Office Action Summary	Application No. 10/712,770	Applicant(s) NAGAYOSHI ET AL.	
	Examiner Dillon Durnford-Geszvain	Art Unit 2622

DETAILED ACTION

Figure A

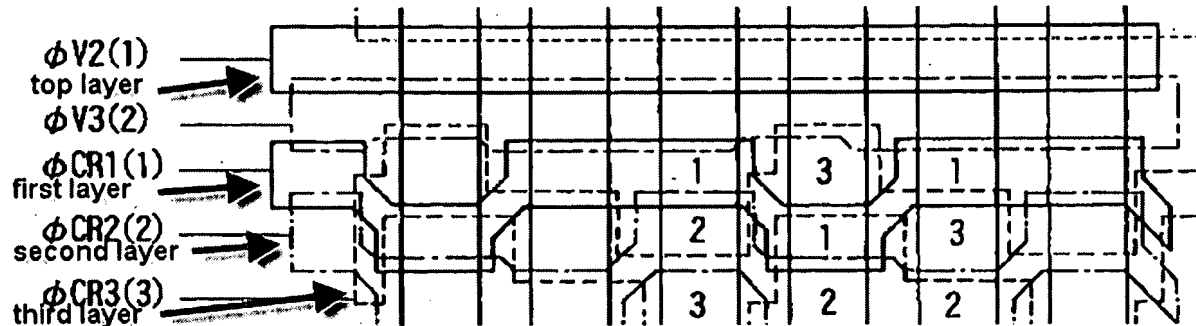
As to claim **25**, see the rejection of claim **1** and note that lizuka further teaches the solid state image sensing device according to claim **1**, wherein the vertical transfer parts have at least three layers of electrode films (see Fig. A below), and the transfer electrodes provided independently of those of vertical last stages of the other columns are formed of at least one of layers of electrode films that includes a top layer (see Fig. A below).
